#### MONTGOMERY COUNTY HISTORIC PRESERVATION COMMISSION

**James Hurley House**

Case No.: 35/56-20A (Amendment) Staff: Dan Bruechert

**Proposal:** Rear deck and new door installation.

Figure 2: Partial site plan showing the existing house and the proposed deck.

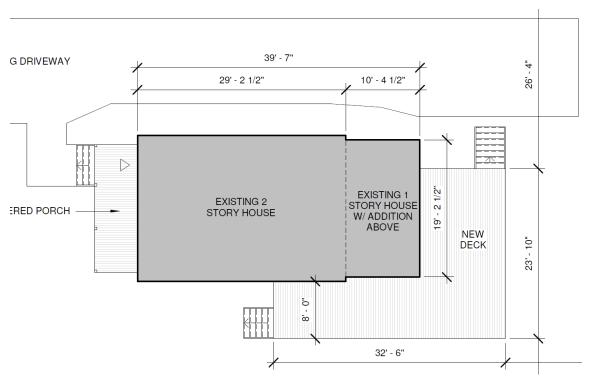
Staff finds that the subject Master Plan Site can support a large deck without significantly impacting the historic character of the Master Plan Site. The proposed deck projects 8' (eight feet) from the right historic wall plane and extends 12' (twelve feet) beyond the rear addition (see below). A set of wooden stairs will be installed at the south and west ends of the porch. The applicant proposes to install a heavy-duty vinyl railing.

Staff finds that the design of the proposed railing is appropriate, but that the material proposed is inappropriate. The simply detailed railing has square pickets set between the top and bottom rails with larger 4" × 4" (four-inch by four-inch) posts. Railings on Master Plan Sites need to be constructed out of historically appropriate materials that will develop a patina with age; in this case, the appropriate material is wood. Staff recommends the HPC include a condition for approval that the deck railing is wood and that the pickets are installed between the top and bottom rail. Verification that this condition has been met and final approval authority should be delegated to Staff. With the identified condition, Staff supports the deck and railing under Chapter 24A-8(b)(1) and (2) and Standards 2, 9, and 10.

1. The proposed deck railing needs to be wood with the pickets installed between the top and bottom rails. Final approval authority to verify this condition has been met should be delegated to Staff.
